URGENT: MEDICAL DEVICE CORRECTION
StealthStation™ S7 Cranial Software v3.1.4
Biopsy Depth Gauge Inaccuracy & Incorrect Distance to Target Text

April 2023

StealthStation™ S7 Cranial Software v3.1.4: Inaccurate Distance to Target Text

Figure 2 Distance to/past Target Text Inaccuracy seen in Navigate Task of Shunt Placement and Tumor Resection

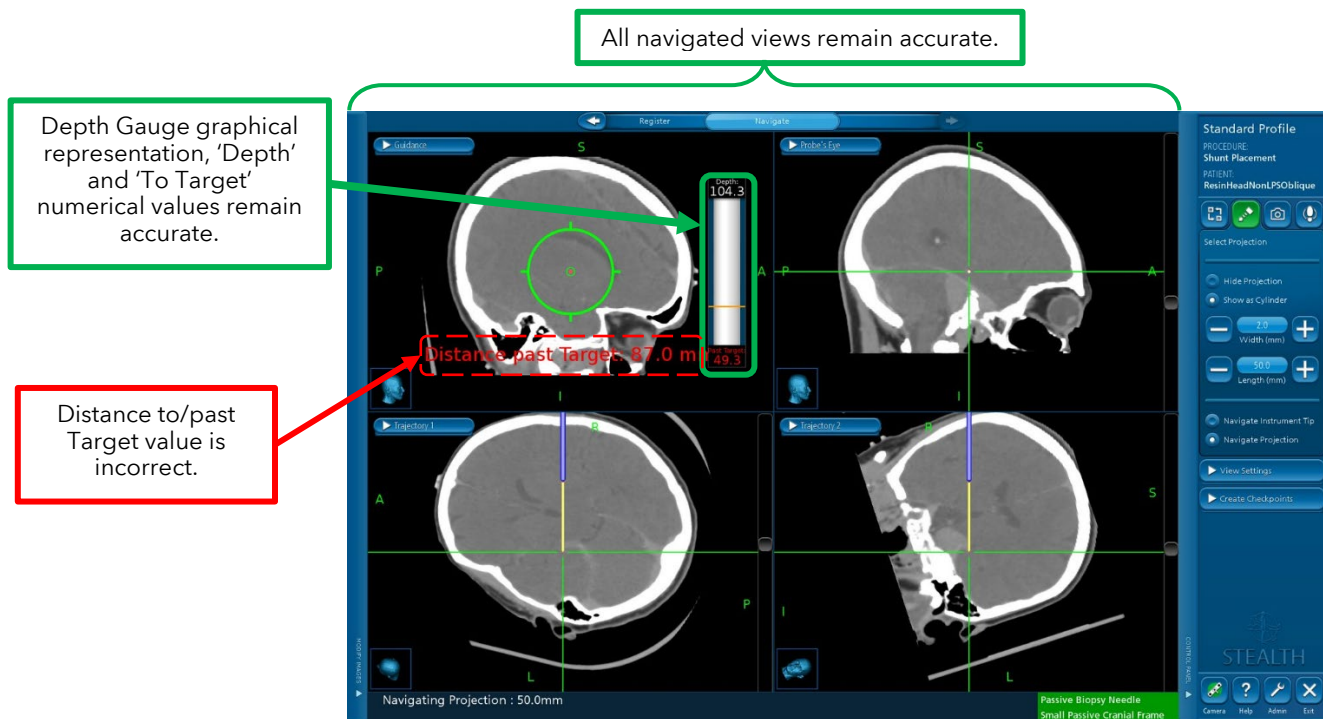
Medtronic identified an anomaly during our own internal testing that impacts Tumor Resection, Shunt Placement, (Refer to Figure 2) and Nexframe™ DBS procedures (Refer to Figure 3) with the Distance to/past Target text. This anomaly does not impact Cranial Biopsy procedures. When certain settings are used, the software can enter a state where the Distance to/past Target text is no longer synchronized with the rest of the navigational information on the screen and displays an inaccurate numerical value. All other information on the screen, including the Depth Gauge Graphic (Shunt Placement, Tumor Resection), remains accurate. The steps required to encounter this anomaly are as follows:

- Non-Axial exams (sagittal, coronal) and a small subset of non-standard Axial exams are used
- A surgical plan has been created and must be utilized.
- The Target Guidance option must be selected within the guidance view options.
- A tip projection must be utilized.
- The 'Navigate Projection' must be enabled.

Medtronic recommends that users do not utilize the Distance to/past Target value (outlined in Red in Figure 2) in Tumor Resection, Shunt Placement, of Nexframe™ DBS procedures due to the potential for the presence of this software anomaly. All other navigation information is unaffected and can be utilized to complete the desired procedure. Per the IFU: "Warning: Frequently confirm navigation accuracy and system responsiveness during live navigation. Use the navigation instrument to touch several bony anatomical landmarks and confirm that the locations identified on the images match the locations touched on the patient. If accuracy degrades, re-register the patient." and "If system navigation seems inaccurate and steps to restore accuracy are unsuccessful, abort use of the system."
